# TDEC for PAM4 ('TDECQ')

Changes to clause 123, to replace TDP with TDECQ

Draft 1

May 3rd 2016

Figure 123-4 — TDECQ conformance test block diagram

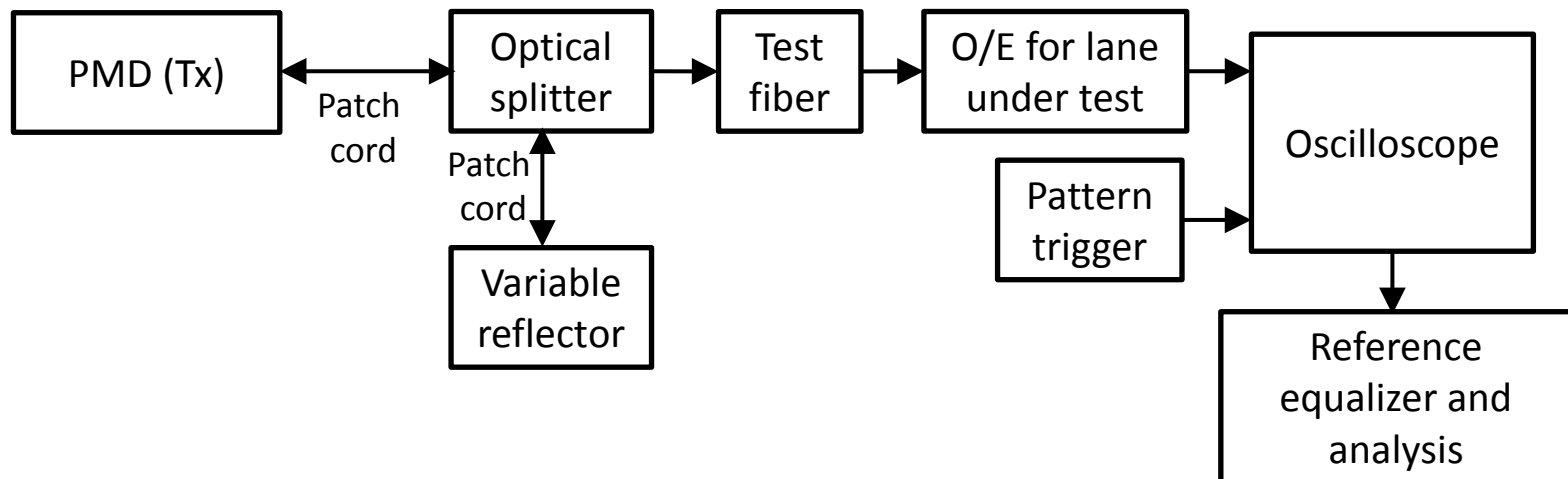
A block diagram for the TDECQ conformance test is shown in Figure 123-4. Other equivalent measurement implementations may be used with suitable calibration.

Each optical lane is tested individually with all other lanes in operation. The optical splitter and variable reflector are adjusted so that each transmitter is tested with the optical return loss specified in Table 123-7. Each optical lane is tested with the test fibers described in 123.8.5.1. The O/E and the oscilloscope combination has a fourth-order Bessel-Thomson filter response with a bandwidth of 19.9 GHz. Compensation may be made for any deviation from an ideal fourth-order Bessel-Thomson response.

The test pattern (specified in Table 123-11) is transmitted repetitively by the optical lane under test and the oscilloscope is set up to capture the complete pattern for TDECQ analysis as described in 123.8.5.3.

# Figure 123-5 Illustration of the TDECQ measurement

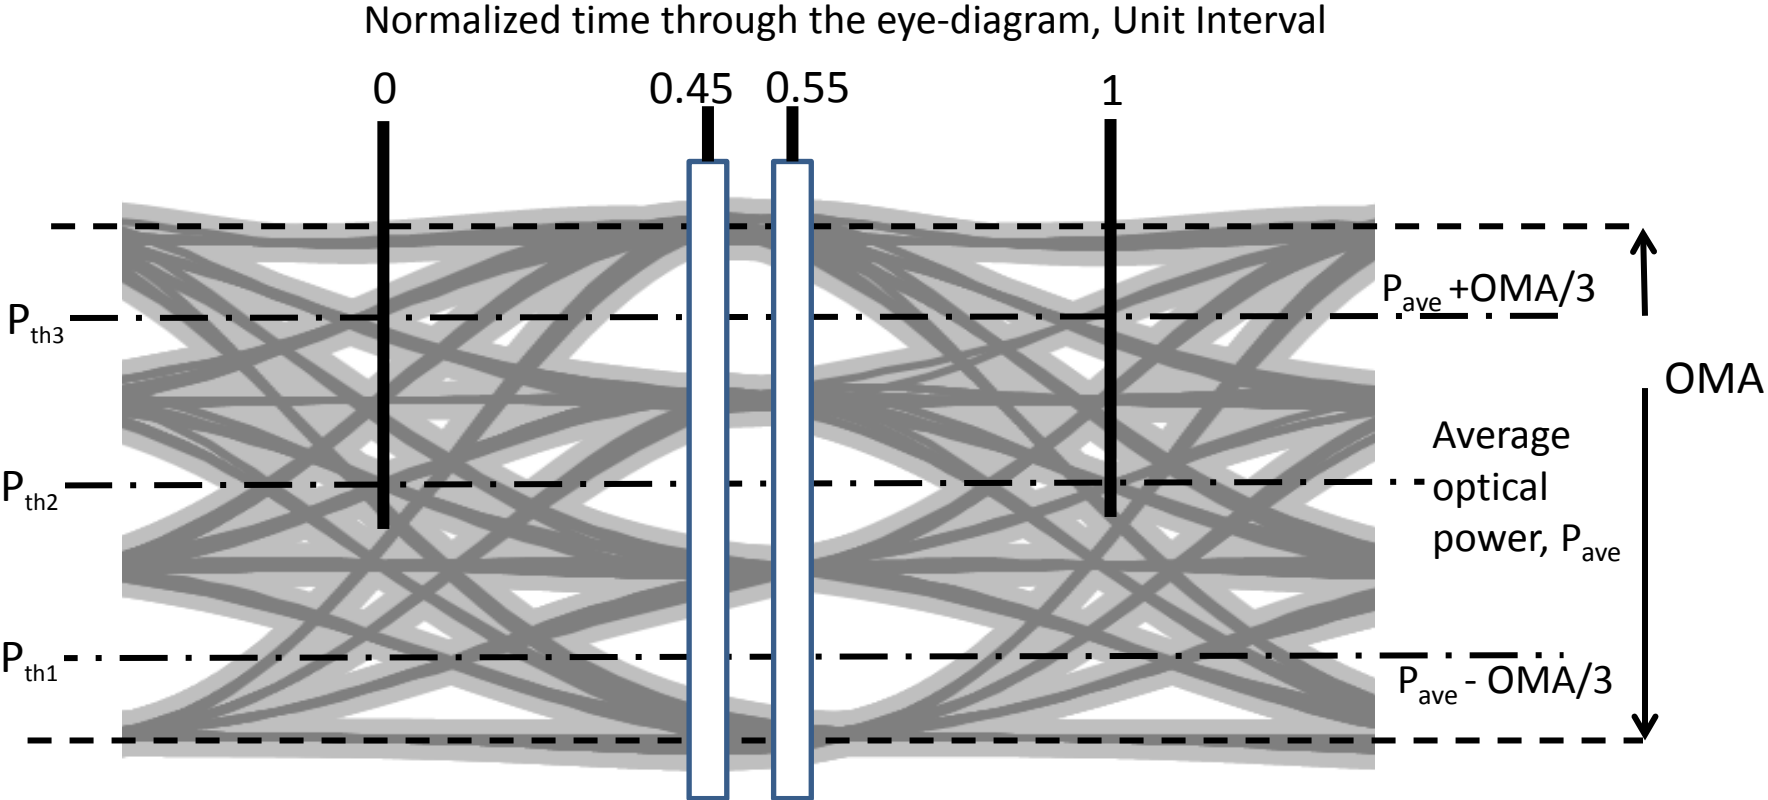
(Time samples/UI? Number of amplitude samples/time sample ? practical limits for number of points?)

The average optical power ( $P_{ave}$ ) of the eye diagram is determined, and the 0 UI and 1 UI crossing points are determined by the average of the eye diagram crossing times, as measured at  $P_{ave}$ , as illustrated in Figure 123-5.

Two vertical histograms are measured through the eye diagram, centered at 0.45 UI (TBD) and 0.55 UI (TBD), each of the histograms spans all of the modulation levels of the eye diagram, as illustrated in Figure 123-5.

Each histogram window has a width of 0.04 UI. Each histogram window has outer height boundaries which are set beyond the extremes of the eye diagram (so that no further samples would be captured by increasing the vertical separation of the height boundaries).
